**NEI 99-06 [Draft Rev. A]**

## **Standard Improved Technical Specifications and Application of Selection Criteria for Fuel Storage Casks**

**MARKUP AND DISCUSSIONS OF CHANGE**  
**FOR HOLTEC INTERNATIONAL HI-STAR 100 CASK SYSTEM**

**ATTACHMENT D.2**  
**MARKUP AND DISCUSSIONS OF CHANGE**  
**FOR TN-32 CASK**

Figure 3.2.1-1  
OVERPACK Surface Dose Rate Measurement Locations

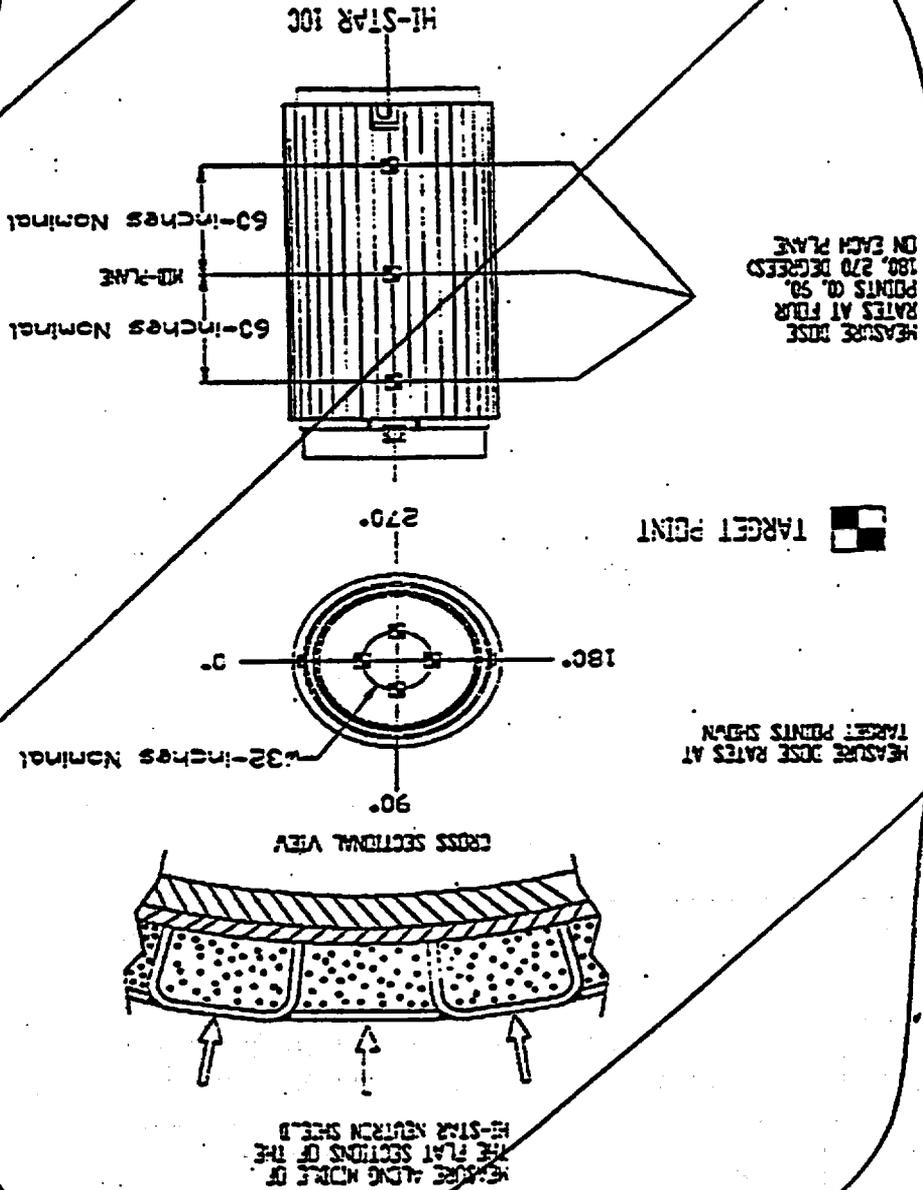
(L.8)

Figure 2.1.1-1  
Burnable Poison Rod Assemblies (BPRAs)  
Minimum Acceptable Cooling Time as a Function of Burnup

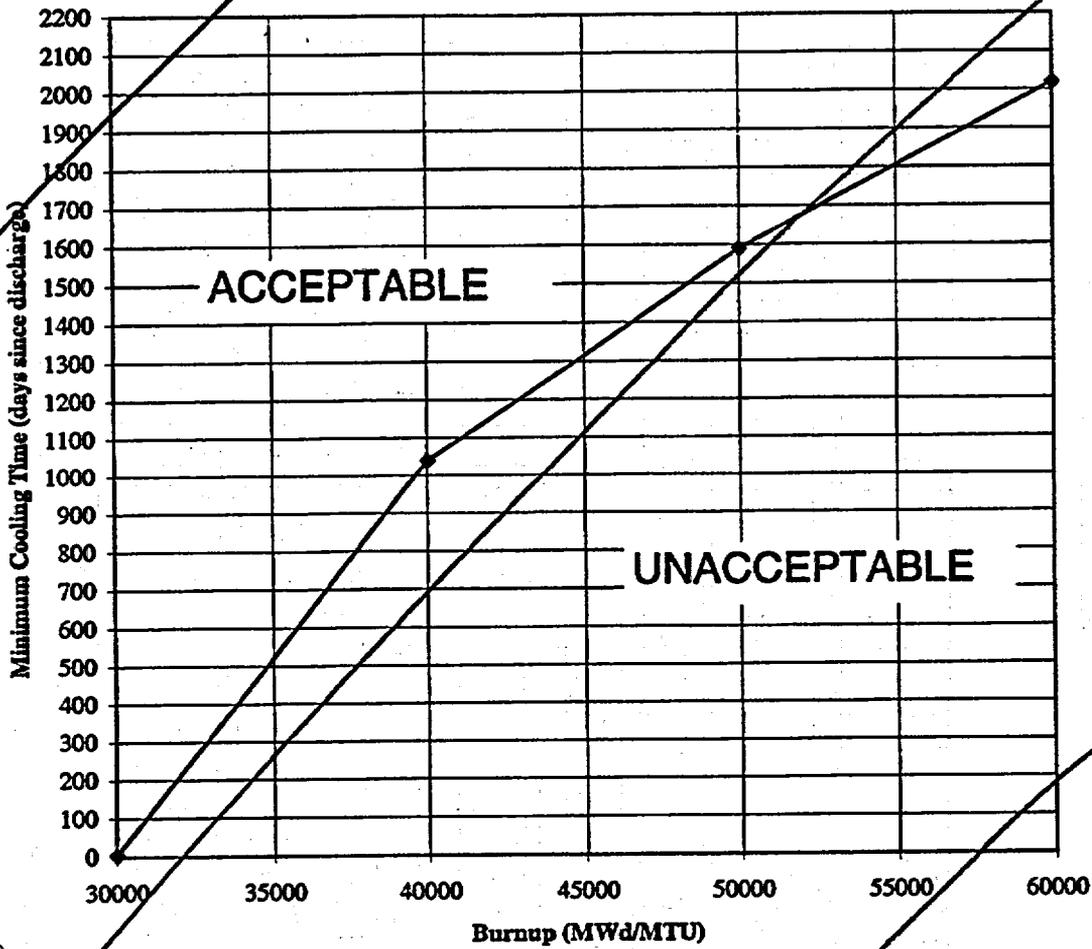
(L.1)

Figure 2.1.1-2  
Thimble Plug Assemblies (TPAs)  
Minimum Acceptable Cooling Time as a Function of Burnup

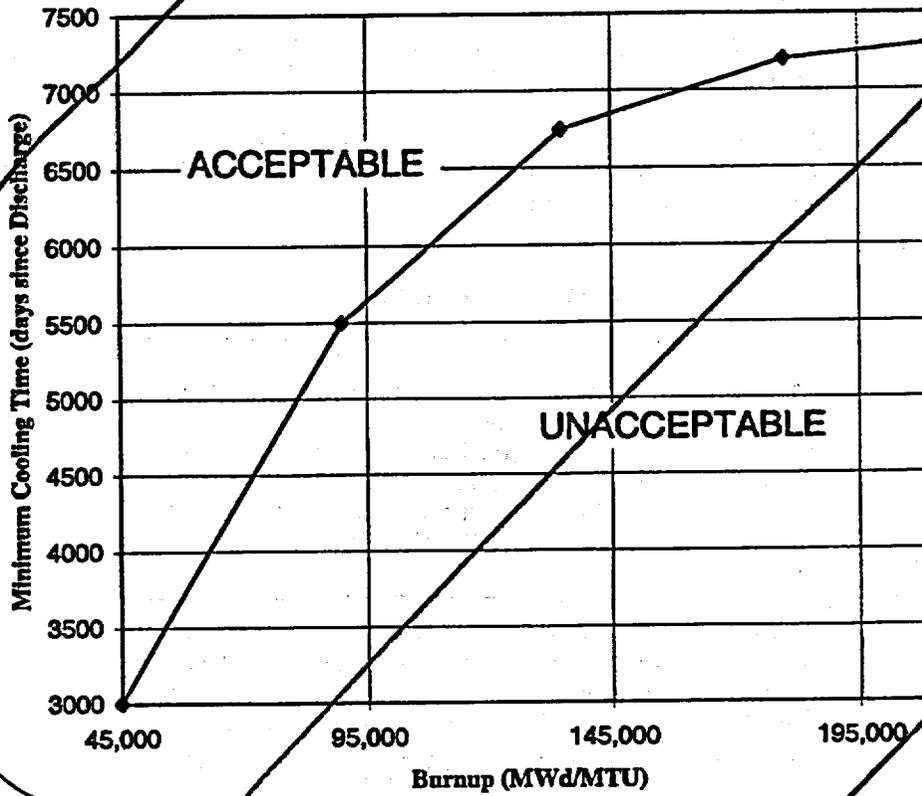
(L.1)

Figure 3-1  
CONCRETE CASK Surface Dose Rate Measurement

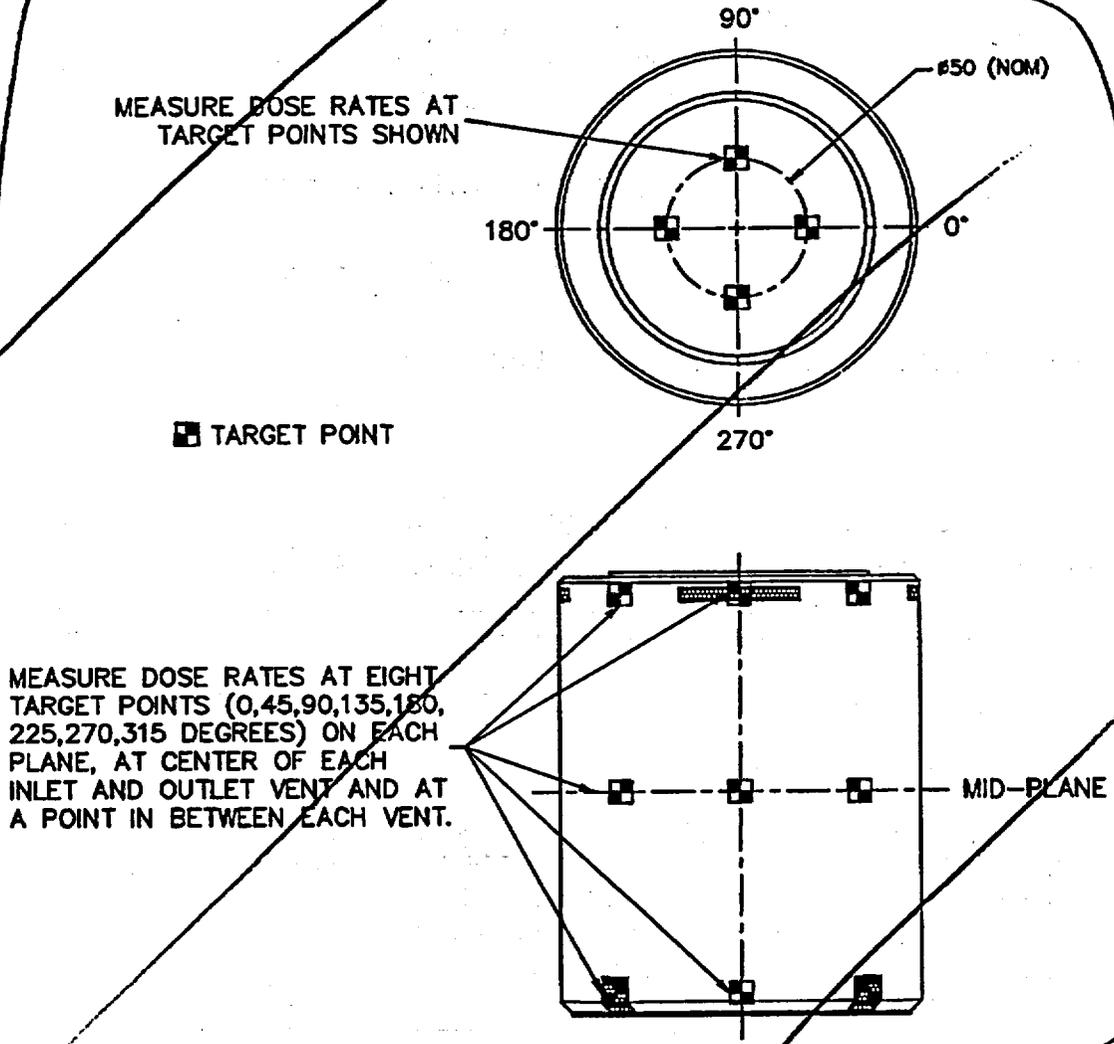
L.8
